Ref. ID ADHOC-D-26-02099
"Onset-Anchored Selective Computation for Resource-Constrained Vehicular Edge Networks"
(submitted as "Trustworthy Selective Computation for Resource-Constrained Vehicular Edge Networks"; retitled in this revision, see R3.7)

Response to Reviewers*

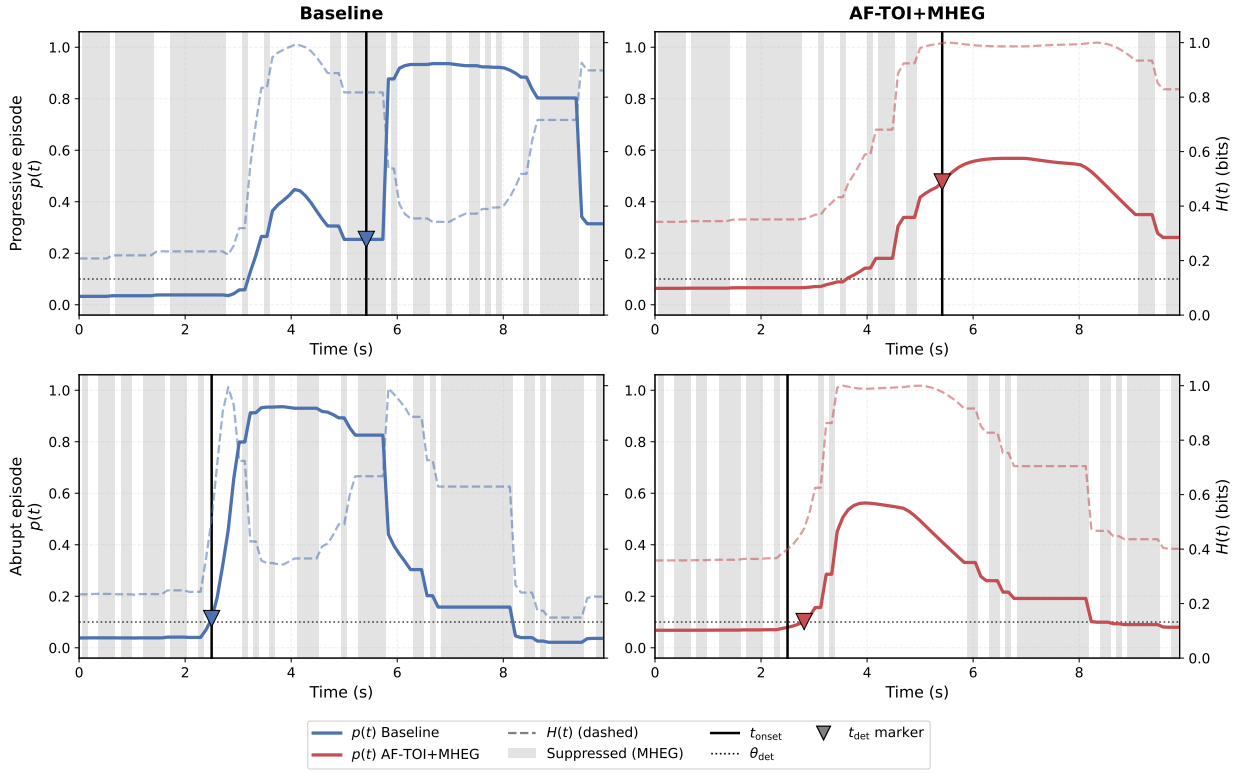
6. Comment: Frame-by-frame temporal evidence for seed 42 graph is not explained well.

Response: We agree with the reviewer. A frame-by-frame reading guide has been added to the paragraph following the first mention of Figure 5 in Section 4.2, identifying each visual element of the seed-42 examples. During revision verification we also found and corrected two problems in this figure, and we report them explicitly rather than silently: (a) the exemplar episodes of the submitted version were not selected by a stated criterion, and the abrupt exemplar was atypical (it belongs to a saturated minority of episodes whose entropy sits near the maximum throughout); the figure now uses, per regime, the episode with the *median* pre/post-onset entropy contrast among seed-42 critical episodes with central onset, and the caption states the criterion; (b) the replay that produced the suppression shading applied the entropy threshold in the wrong logarithm base (natural log instead of the base-2 entropy of Eq. 11), so the entropic branch of the gate never fired in that log; the log was regenerated with the correct base, and the entropy axes of Figures 4–6 are now uniformly

in bits, matching Eq. 11. The added text reads:

(The full frame-by-frame reading guide follows the first mention of Figure 5 in Section 4.2.) Its selection criterion reads: "The exemplars are selected by a pre-declared neutral criterion: within each regime, the episode whose pre/post-onset entropy contrast is the *median* among the critical episodes of seed 42 with a centrally located onset (progressive: episode 36, t_0=5.42 s; abrupt: episode 148, t_0=2.50 s)." The guide also states that detection markers of single exemplars do not arbitrate latency (aggregate latencies are settled by Table 8) and that a minority of abrupt critical episodes (12 of 48 in seed 42) runs near maximal entropy throughout. The regenerated figure is reproduced below.

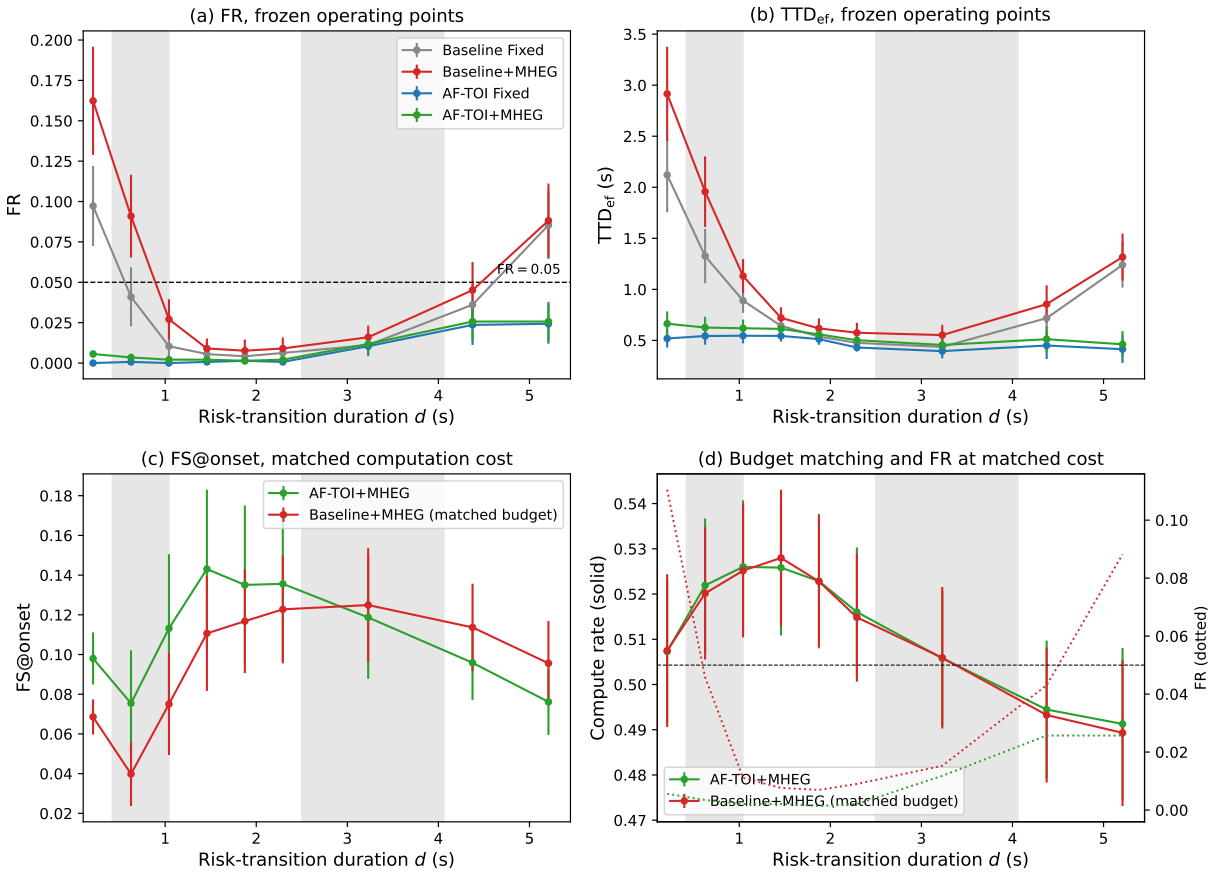
4. Comment: A central claim of the study is that temporal organization of uncertainty is important for safe selective computation, but the current experiments appear to be strongly tied to the risk-transition patterns defined by the experimental setup. The authors should investigate whether AF-TOI generalizes to unseen temporal risk trajectories, different onset durations, abrupt versus gradual transitions, intermediate-risk conditions, changes in the distribution of input features, or distribution shifts between training and testing conditions.

Response: We agree with the reviewer. To address the question of generalization across different transition durations, a new temporal-scale experiment has been added in Section 4.12, together with Figure 14 and Table 21. The experiment varies the risk-transition duration independently through a shape-preserving temporal warp while keeping t_0, the normalized transition shape, the episode context, the model weights, and the scheduler thresholds fixed. The limitations paragraph of Section 5 was also revised to distinguish this controlled temporal train–test shift from broader naturalistic distribution shift. The six aspects raised in the comment are addressed as follows.

(ii) *Different onset/transition durations* are evaluated by the new experiment of Section 4.12, across nine durations from 0.21 to 5.21 s, including interpolation and extrapolation outside the training support.

The new Section 4.12 (Figure 14, Table 21) reads:

"Figure 14a–b and Table 21 report the frozen operating points. AF-TOI maintains mean FR below 0.05 at every evaluated duration (maximum duration-wise mean 0.026), and $\mathrm{TTD}_{\mathrm{ef}}$ stays within approximately 0.40–0.66 s. The Baseline crosses mean FR = 0.05 at both extrapolation extremes (mean FR 0.097 at 0.21 s and 0.085 at 5.21 s for the fixed policy), and its $\mathrm{TTD}_{\mathrm{ef}}$ follows a U-shaped profile that reaches 2.12 s at the fast extreme. At the level of individual seed×duration cells, AF-TOI exceeds FR = 0.05 in 7 of 108 cells (all at $d \geq 3.23$ s, maximum 0.108), against 22 of 108 for the fixed Baseline (maximum 0.250) and 32 of 108 for Baseline+MHEG (maximum 0.333). Frame-level F1 remained seed-sensitive under the warp, a pattern consistent with checkpoint-level variability rather than with an effect of the warp itself. Accordingly, the result is restricted to aggregate coverage and effective delay and does not constitute a per-seed guarantee: AF-TOI shows aggregate temporal-scale robustness across the evaluated synthetic range of unseen risk-transition durations." (Section 4.12, second paragraph)

"Because the two frozen gates suppress different fractions of frames, we added a post-hoc matched-budget diagnostic: for each seed×duration cell, the entropy threshold of Baseline+MHEG was adjusted by bisection (...) until its computation rate (fraction of executed window updates; both arms share the recompute semantics of Section 3.4) matched that of AF-TOI+MHEG on the same cell (all 108 cells matched within 1.9%, tolerance 2%; Figure 14d). (...) At matched computation cost, no systematic FS@onset advantage remains (...). Under Holm correction within each endpoint family, only the $\mathrm{TTD}_{\mathrm{ef}}$ difference at 0.21 s remains significant ($p = 0.031$), so these per-duration matched-cost contrasts should be read as exploratory. The matched-budget diagnostic supports a temporal-scale coverage-and-timeliness advantage, not a universal improvement in near-onset suppression placement." (Section 4.12, third paragraph)
